IER # 12 - Appendix A

IER # 12 - Appendix B

**RE: DRAFT INDIVIDUAL ENVIRONMENTAL REPORT 12 AND PROPOSED MODIFICATION TO 404(C) ACTION**

**Re: Combined public hearing on the Draft IER-12, on the modification of CWA Sec. 404(c) determination for Bayou aux Carpes; and hearing on GIWW West Closure Complex.**

Figure 1. Aerial photograph showing the Belle Chasse-Westwego Segment (IER 12) for the West Bank Hurricane Protection Levee.

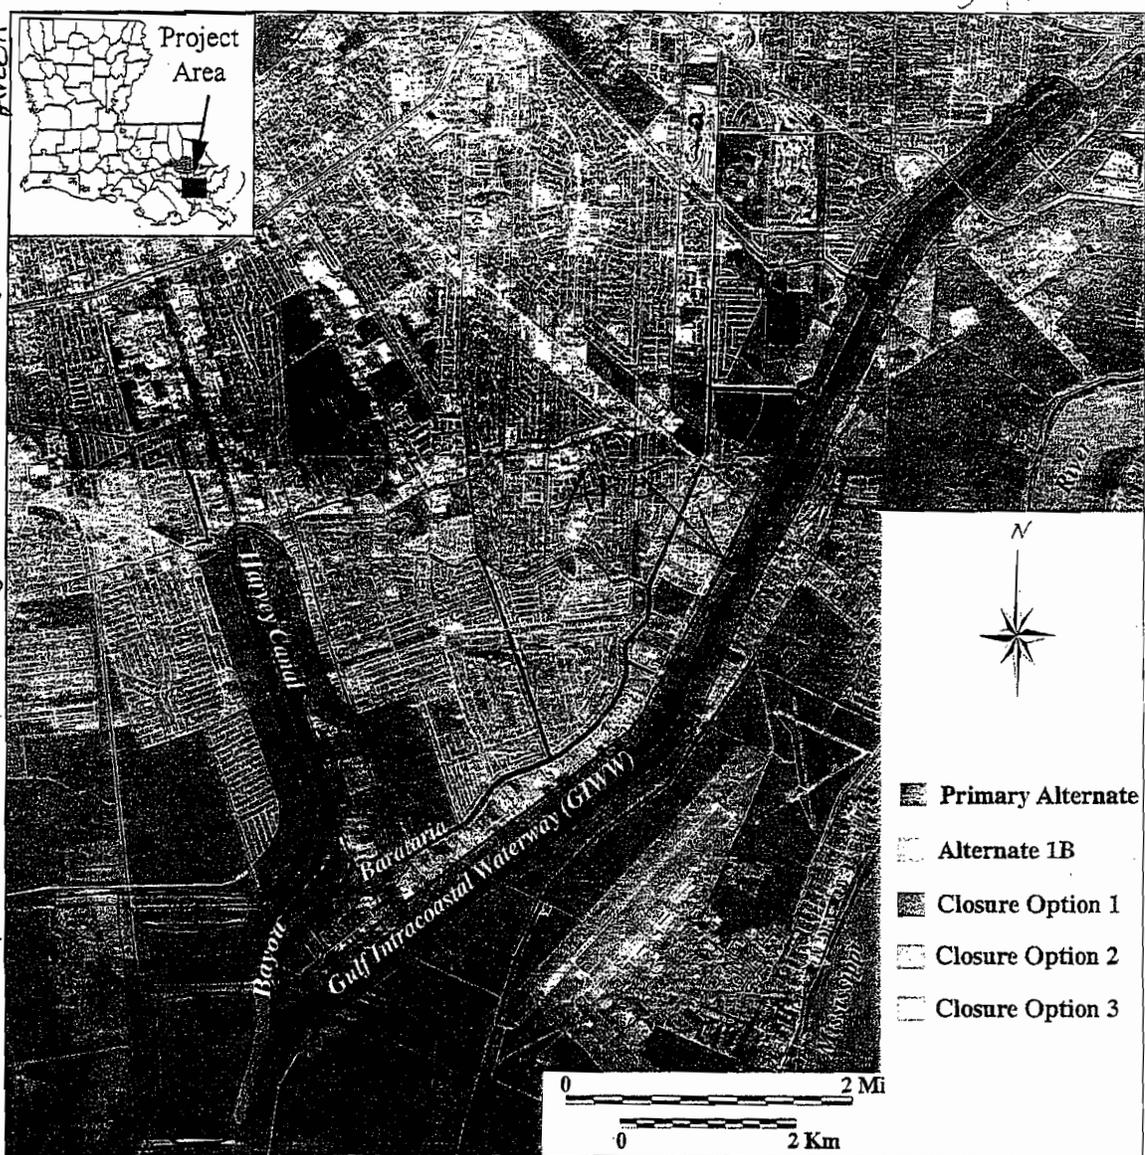
None of  
 these are  
 shown on  
 Figure 1.

*Canal shown in 19th century maps  
or other maps.*

*EWALACE to whole page and include gate/catchment survey  
AVLEBA*

## CURRENT PROPOSED SITE PLAN

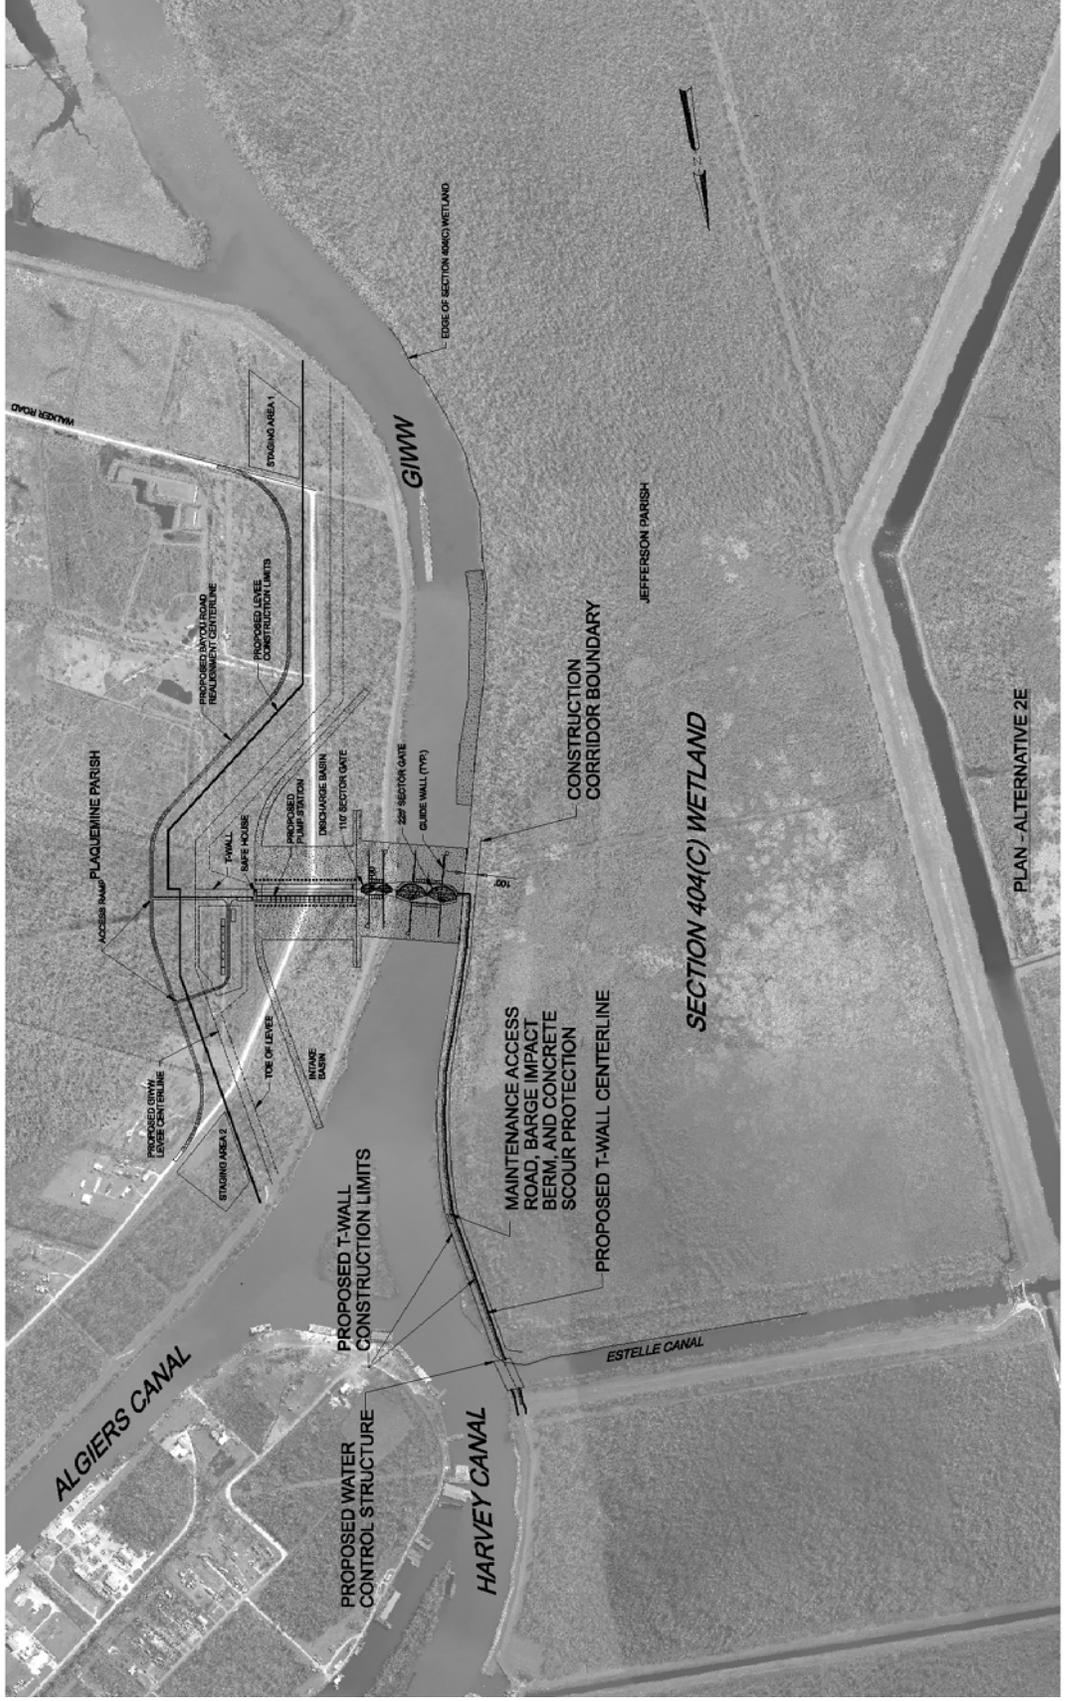
- Appendix K (Figure entitled, "Current Proposed Site Plan"): The description states that the "orientation of the pump station, gates, bypass channel and levee on east side of GIWW are not final and could change as design progresses." This means that there is still some flexibility and the final engineered design could avoid the 404(c) wetlands.

We did not find one map that identified the location of the existing Enterprise pipeline nor a discussion of the impacts of relocation of the pipeline on the BAC wetlands. In Appendix K figure 1 is a dashed line labeled pipeline relocation. Does this pipeline belong to Shell? It is identified on earlier corps maps as a Shell pipeline (USACE, 1971). There should be a full discussion describing how the relocation will prevent any direct or indirect impacts to the BAC. Will the old pipeline be removed? How old is it? How much will be relocated? Between what reference points will the work be done? (point A to point B). Will the pipeline segment reconnect to the old pipeline. We request the amended IER include an expansion of the discussion section fully explaining the pipeline relocation procedure and impacts to the BAC.
